May 31, 2016

Re: FirstLight Hydro Generating Company, Turners Falls Hydroelectric Project (FERC No. 1889) and Northfield Mountain Pumped Storage Project (FERC No. 2485).
Response to Stakeholder Requests for Study Modifications and/or New Studies Based on the Study Report and Meeting Summary

FIRSTLIGHT HYDRO GENERATING COMPANY
Northfield Mountain Pumped Storage Project No. 2485
Turners Falls Hydroelectric Project No. 1889

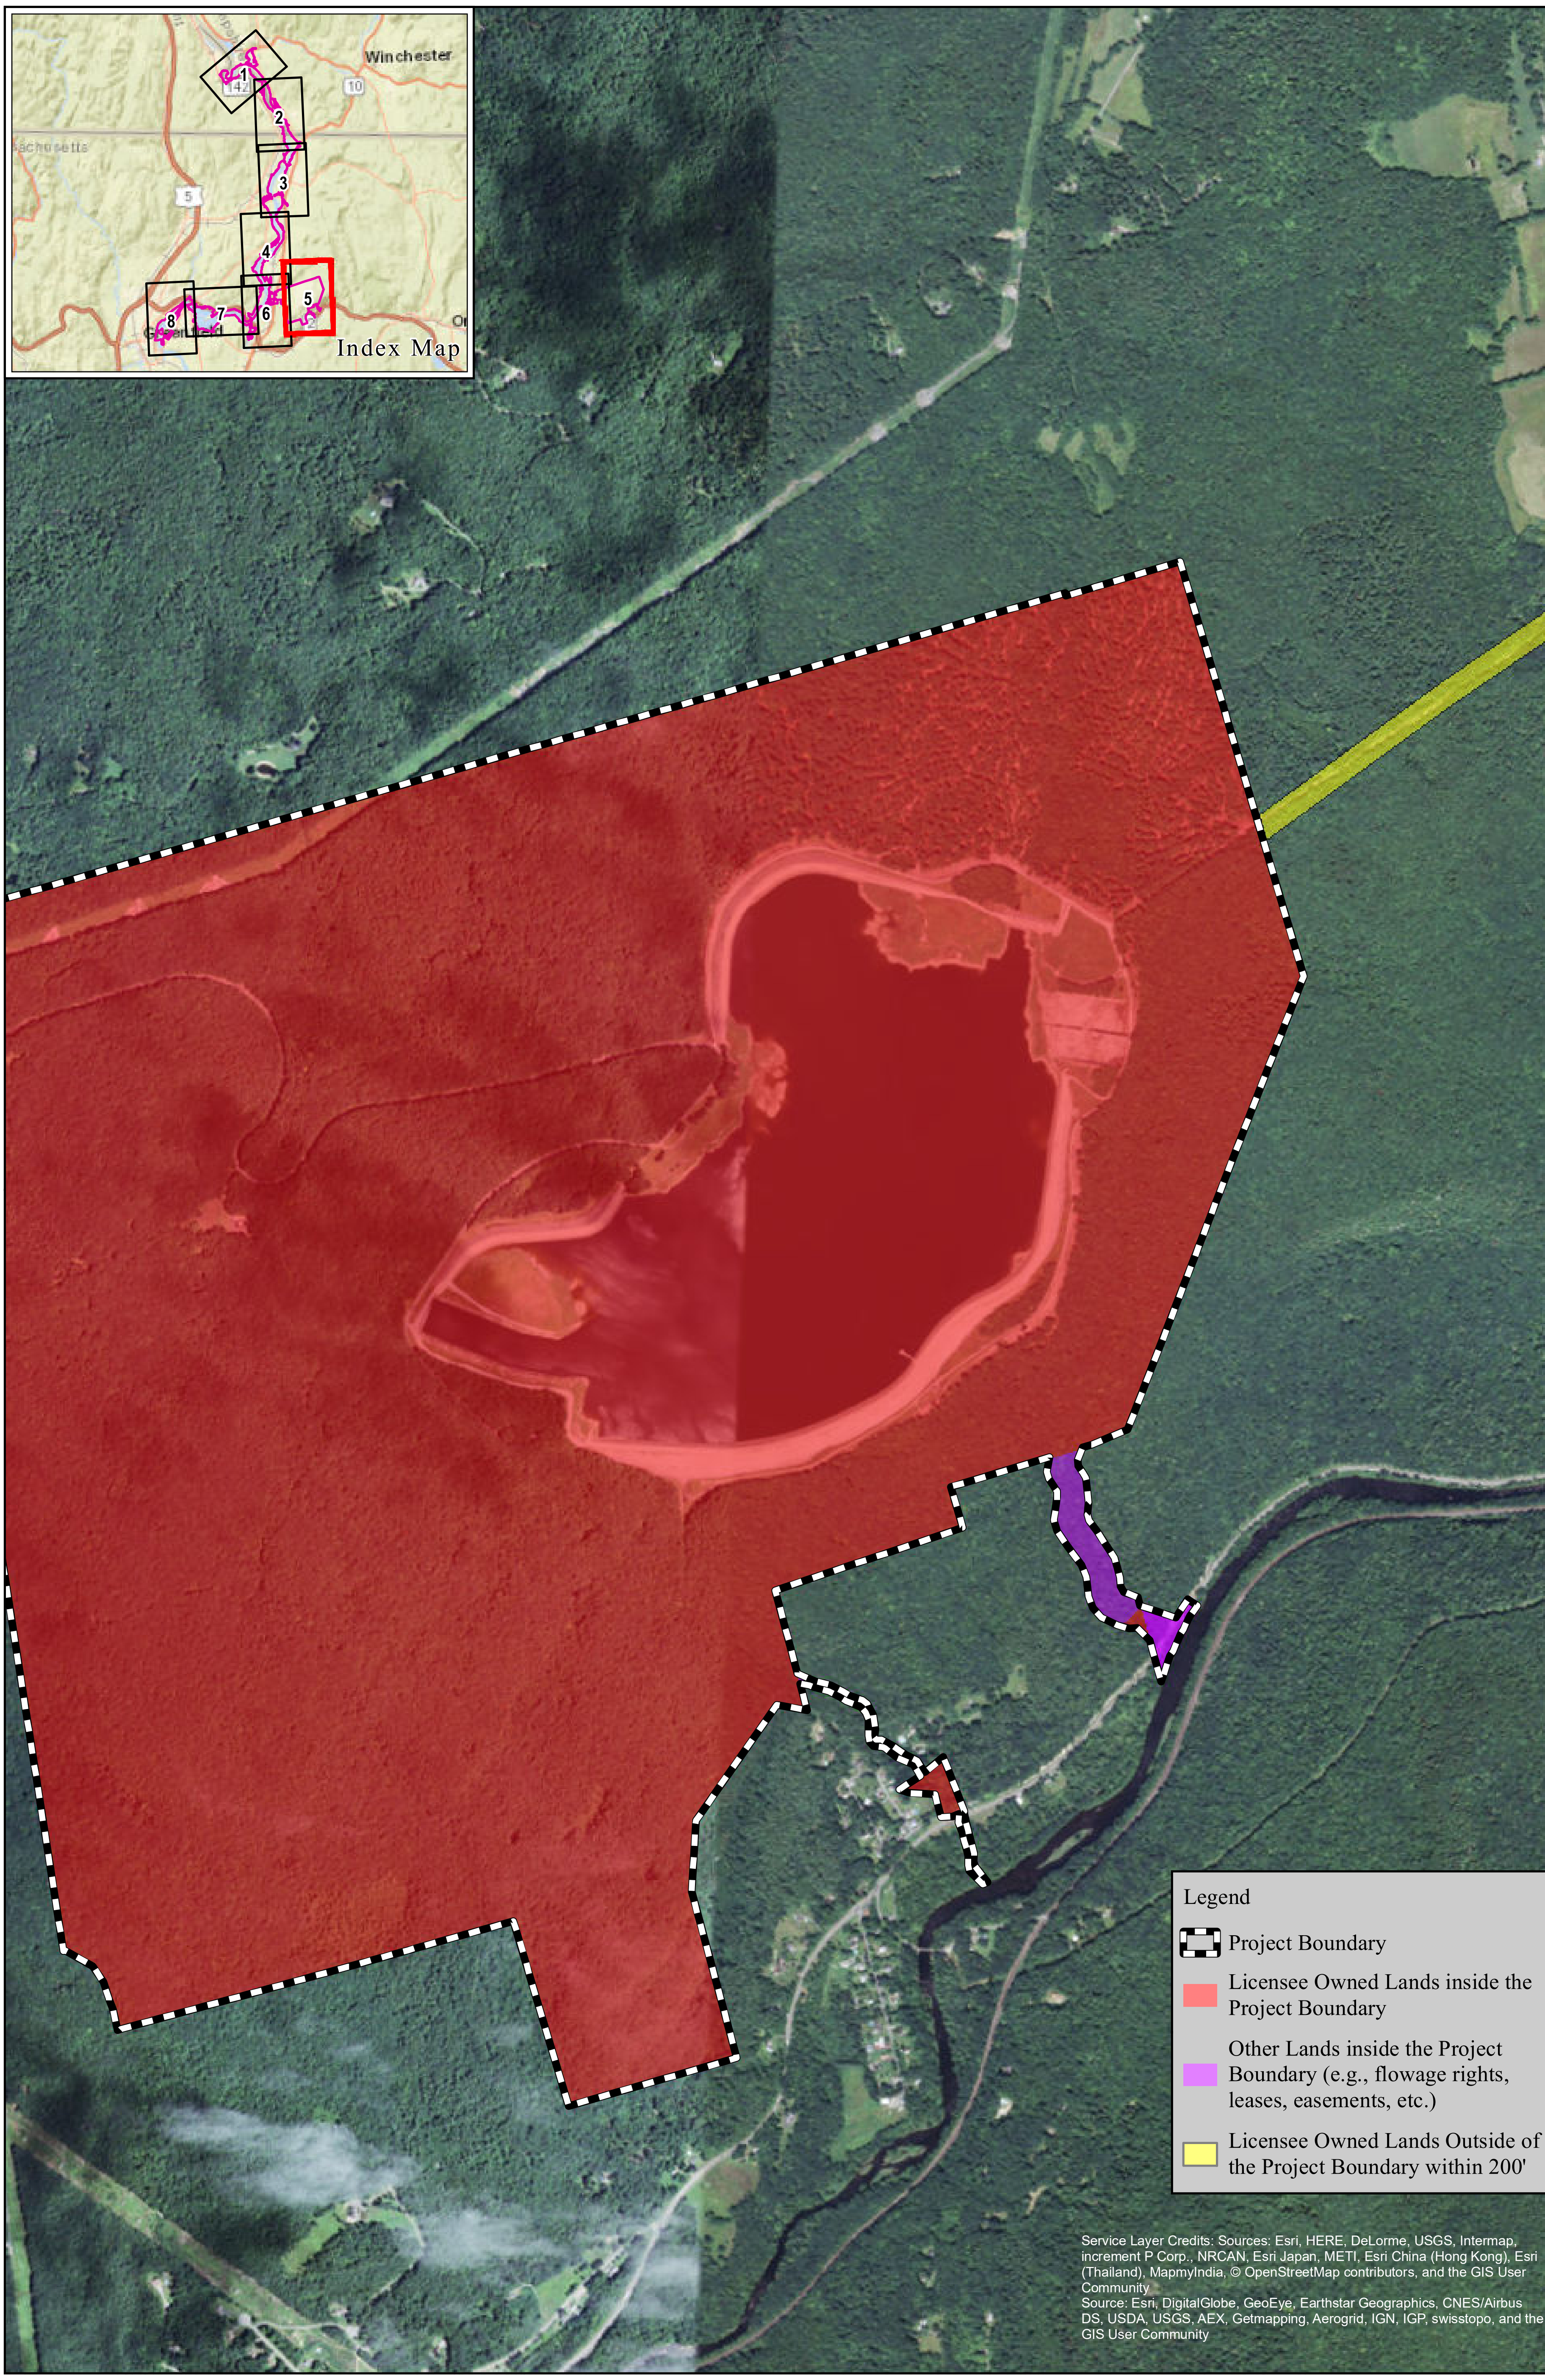
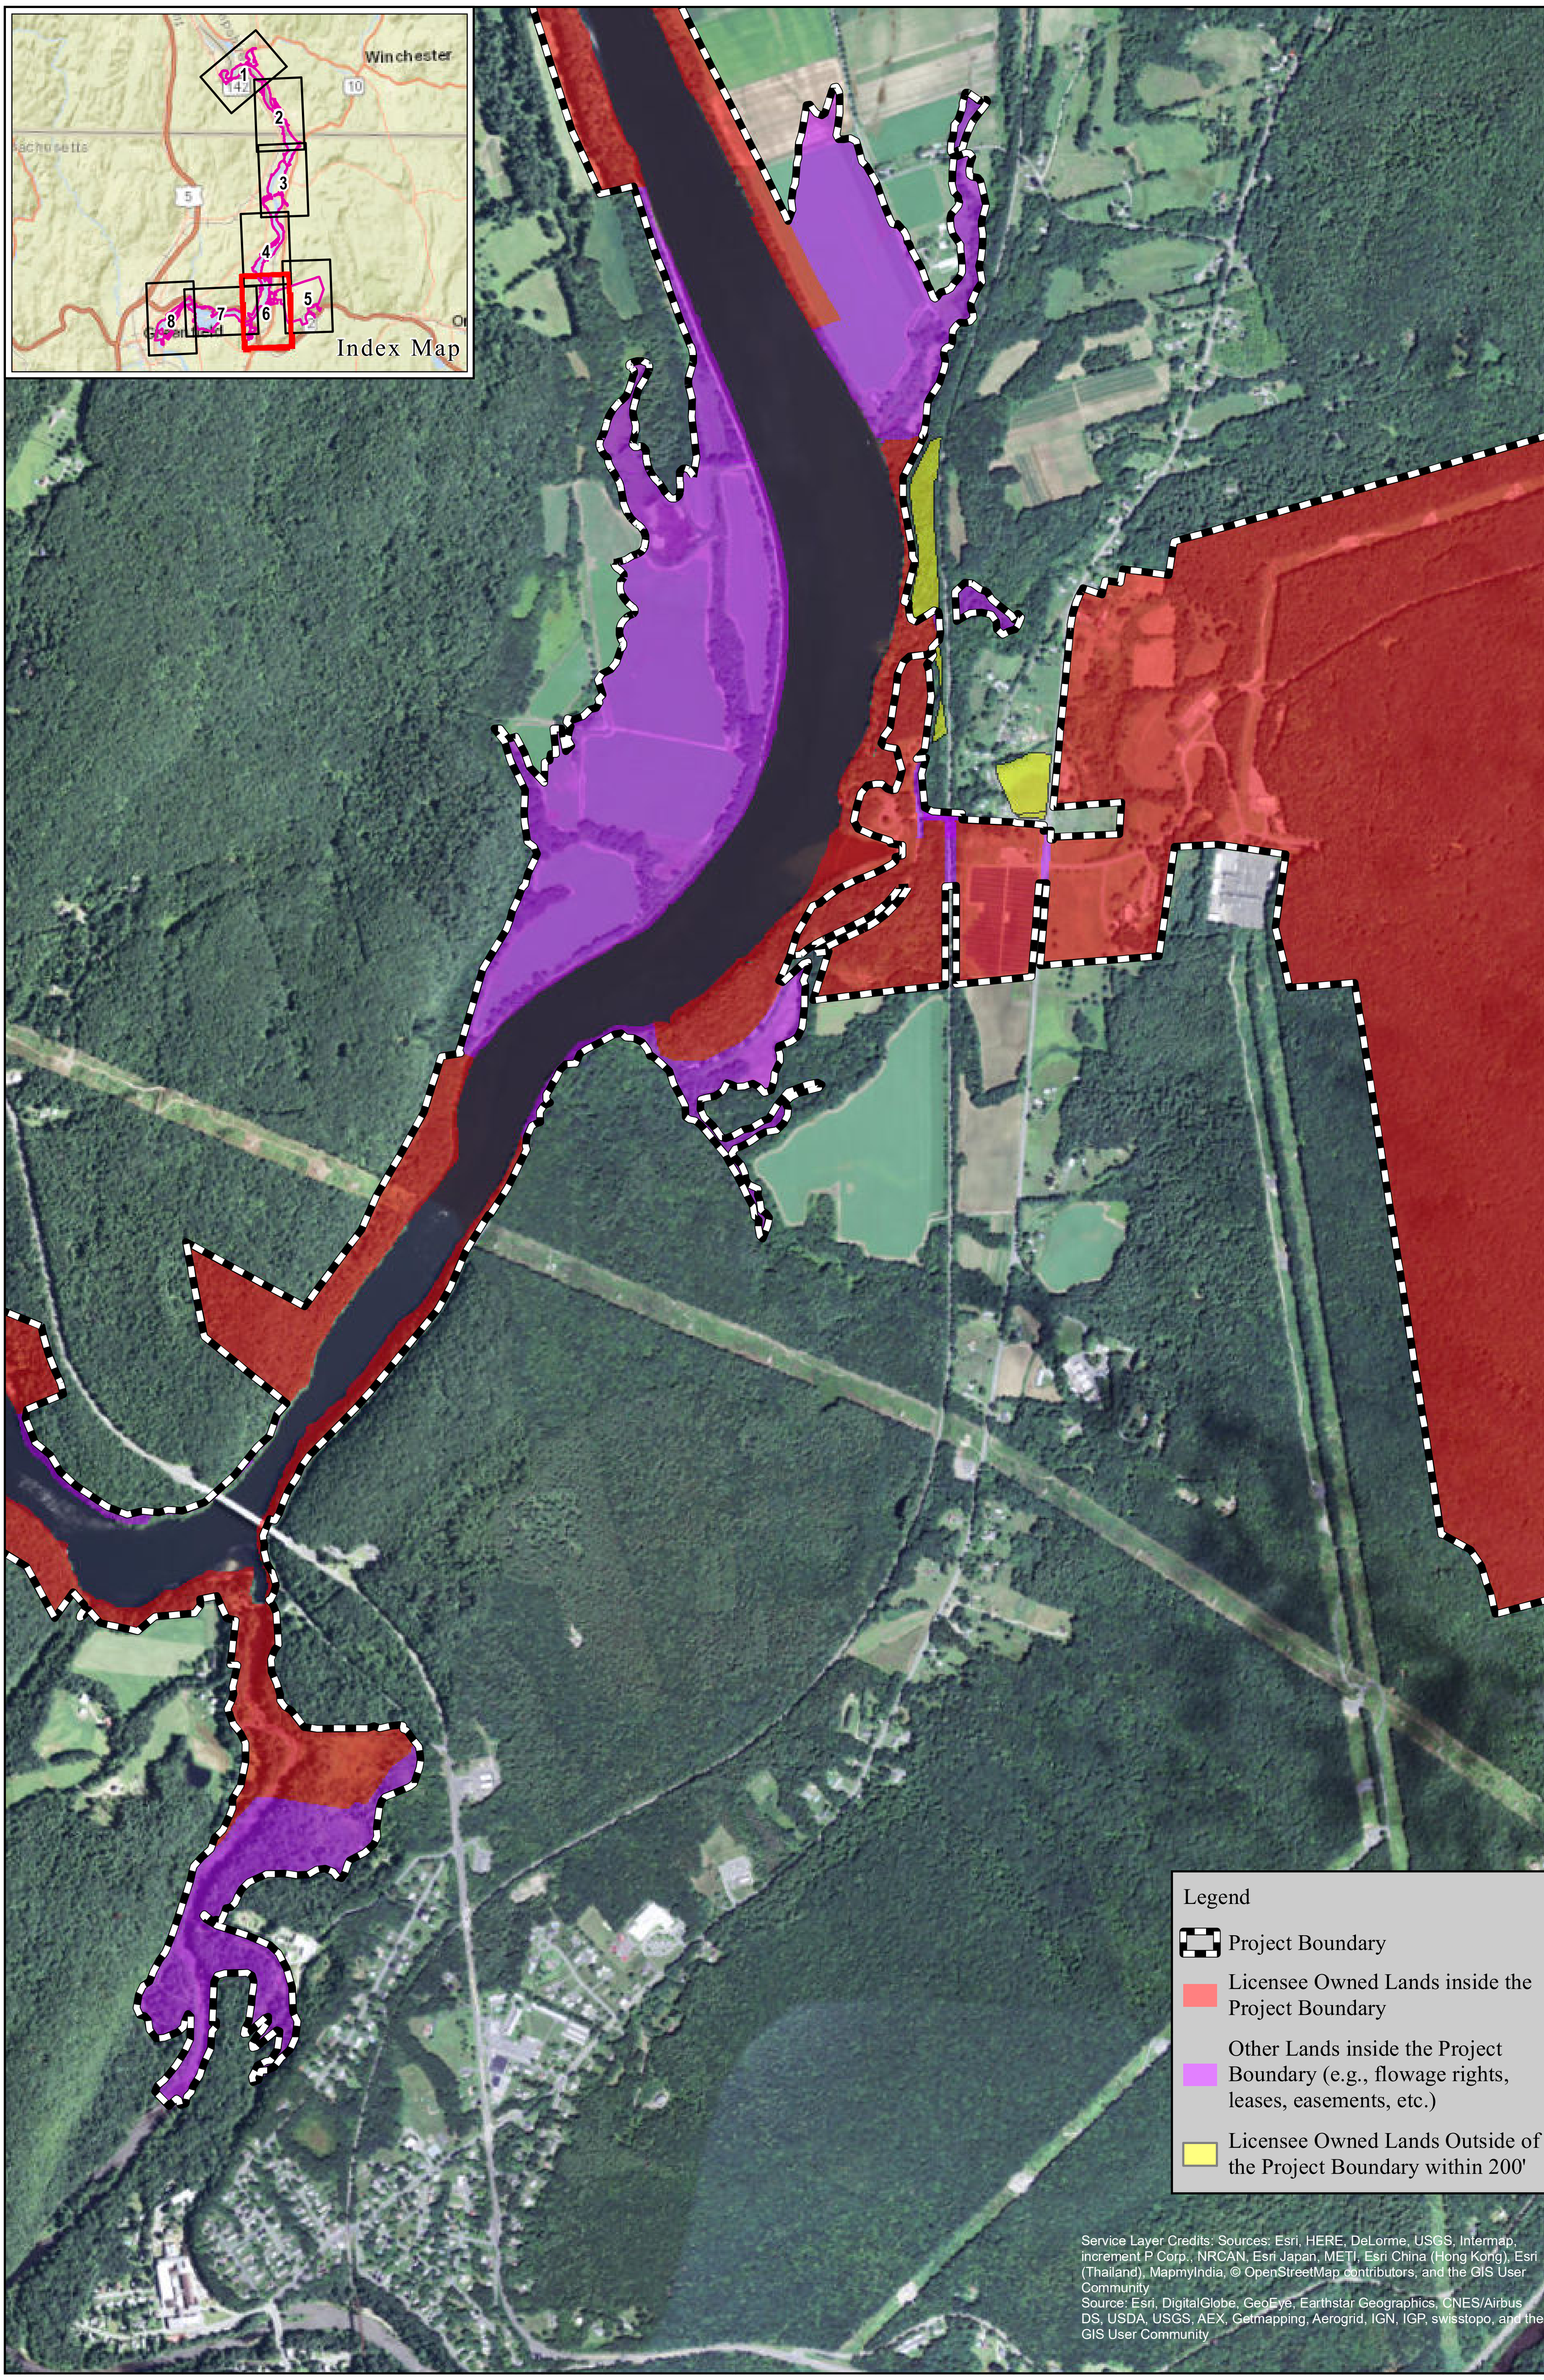
Commenter	Comment	Responses
CRWC-1	The report does not identify ownership and other controls such as FirstLight's flowage rights within the Project boundaries. FirstLight does not own all of the lands within the project boundaries. FirstLight ownership of lands within 200 feet of the Project boundaries is identified in Figure 4.4-1, but nothing indicates ownership within the boundaries. CRWC requests that FirstLight provide information on land it has ownership or any other control over, and the land use associated with those lands, in an addendum to Study 3.6.5.	FL has updated the maps that comprise Figure 4.4-1 in the 3.6.5 study report to show FL land ownership within the project boundary. See Study 3.6.5 Attachment A, Figure 4.4-1. The lands owned by FL shown are fee-ownership. The figures also show other lands within the Project boundary (e.g., flowage rights, easements, leases, etc.). The land uses associated with all lands within the Project boundary are provided in the 3.6.5 study report. An addendum to the 3.6.5 study report is not necessary.
